AMENDMENT NO. 1 OCTOBER 1987**TO**

**IS : 3347 (Part 5/Sec 2)- 1979 DIMENSIONS FOR
PORCELAIN TRANSFORMER BUSHINGS FOR USE
IN NORMAL AND LIGHTLY POLLUTED
ATMOSPHERES**

PART 5 36 kV BUSHINGS**Section 2 Metal Parts****(First Revision)**

FIG. 23(B) CONNECTING LUG (FOR 36 kV/2 000 AND 3 150 A RATING)

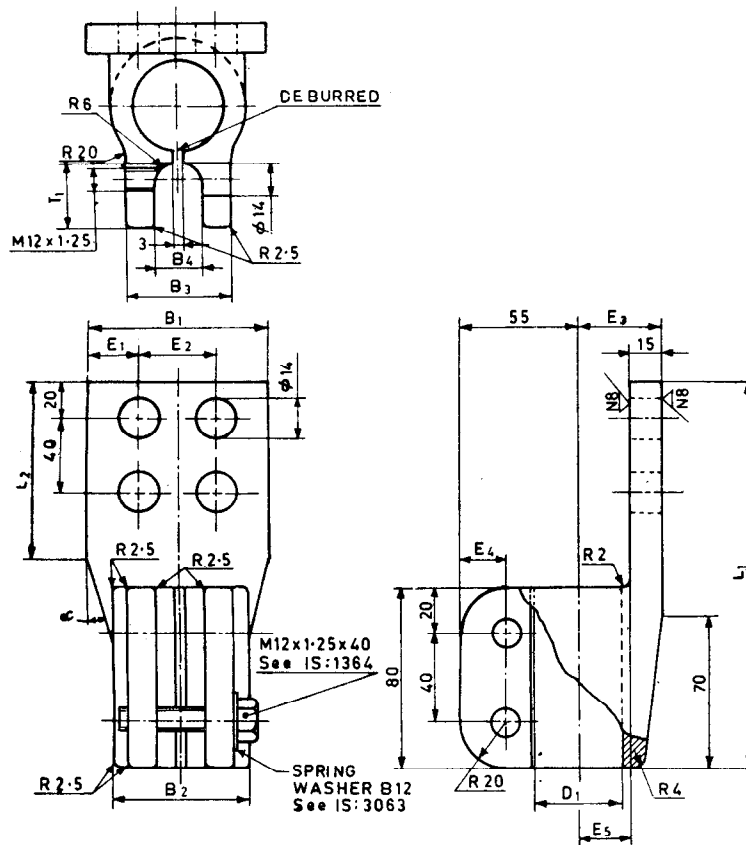
[Page 24, Fig. 23(B), Form A] — Substitute the following figure for the existing figure:

STEM SIZE	D_1	B_1	B_2	B_3	B_4	E_1	E_2	E_3	E_4	E_5	L_1	L_2	L_3	L_4	T_1	α	FOR NOMINAL CURRENT RATING
M 42 × 3	M 42 × 3	100	58	45	20	25	50	40	20	25	190	100	105	155	26	26°	2 000 A
M 48 × 3	M 48 × 3	120	68	58	28	30	60	45	18	30	210	120	125	175	28	30°	3 150 A

FIG. 23(B) CONNECTING LUG (FOR 36 kV/2 000 AND 3 150 A RATING)

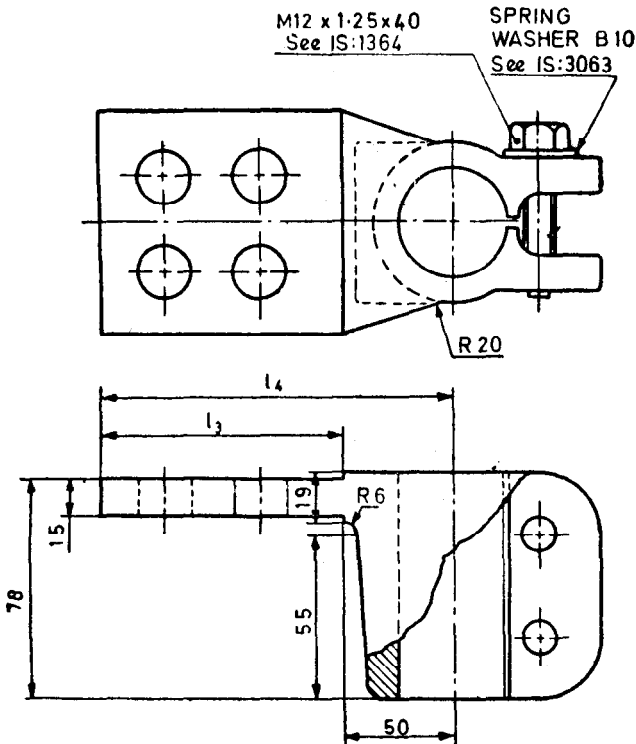
[Page 25, Fig. 23(B), Form B] — Substitute the following figure for the existing figure:

NOTE — Let other details refer to Fig. 23(B), Form A.

FIG. 29 BUSHING ASSEMBLY (FOR 36 kV/250 A RATING)

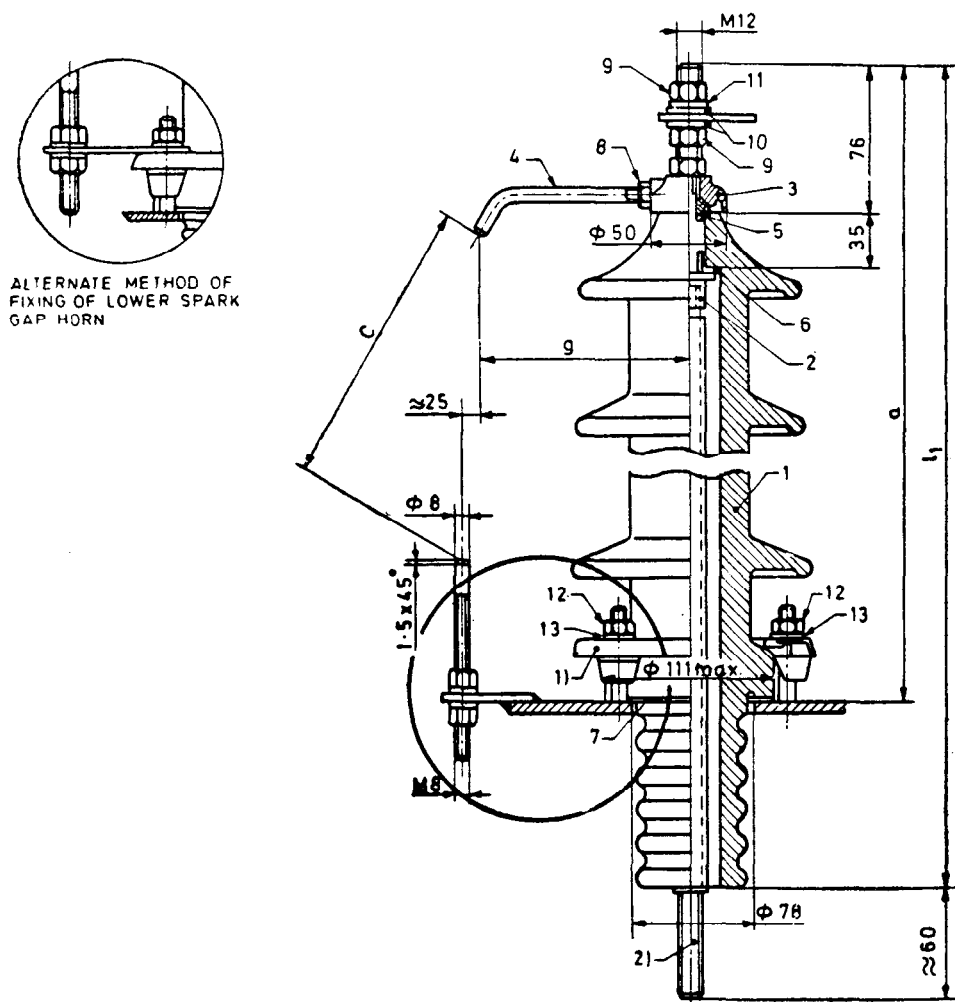
(Page 29, Fig. 29) — Substitute the following figure for the existing figure:

Alternate arrangement for fixing of lower spark gap horn may be used.

1. Clamping arrangement of bushings shall be according to IS : 4257 (Part 1)-1981*.
2. The connecting bolt and the stem may be made in one piece.

BUSHING RATING kV/A	<i>a</i>	<i>C</i>	<i>g</i>	<i>l₁</i>
36/250	485	220	170	561

FIG. 30 BUSHING ASSEMBLY WITH COPPER STEM
(FOR 36 kV/630 A RATING)

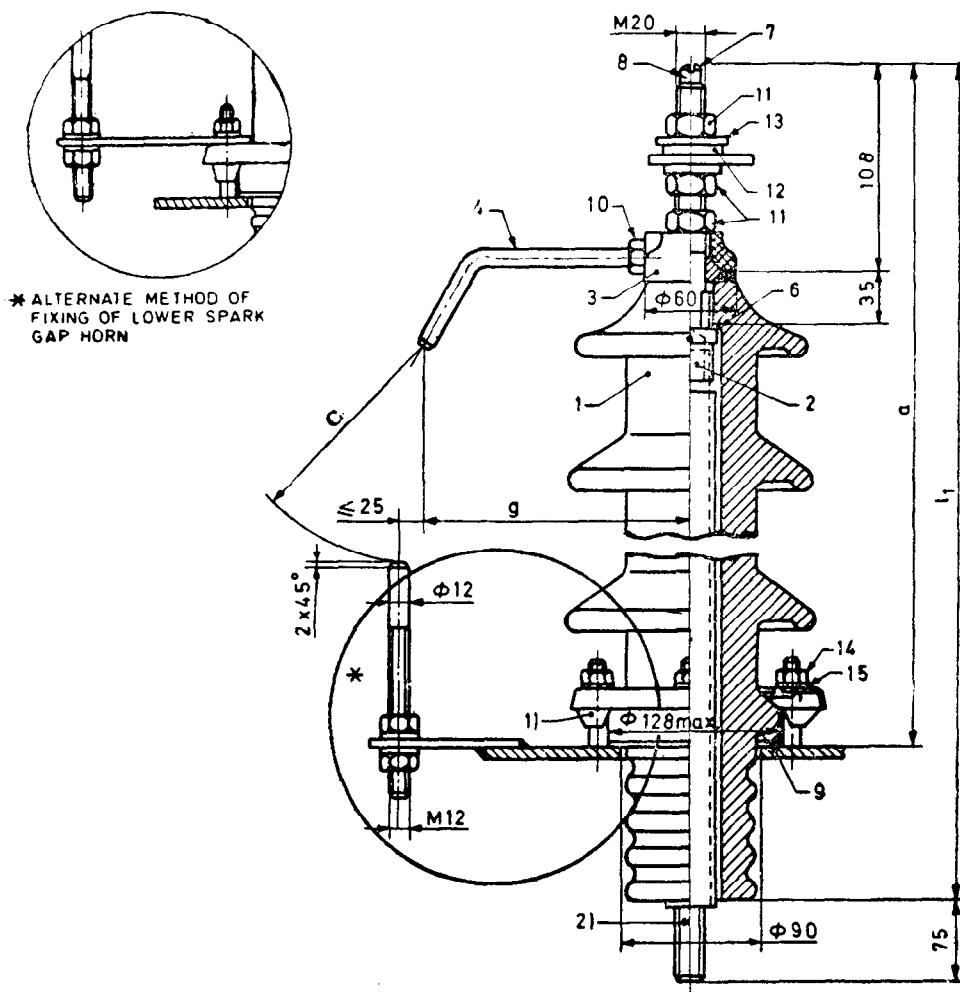
(Page 30, Fig. 30) — Substitute the following^{*} new figure for the existing figure:

Alternate arrangement for fixing of lower spark gap horn may be used.

1. Clamping arrangement of bushings shall be according to IS: 4257 (Part 1)-1981*.
2. The connecting bolt and the stem may be made in one piece.

BUSHING RATING kV/A	a	C	g	l ₁
36/630	522	220	200	618
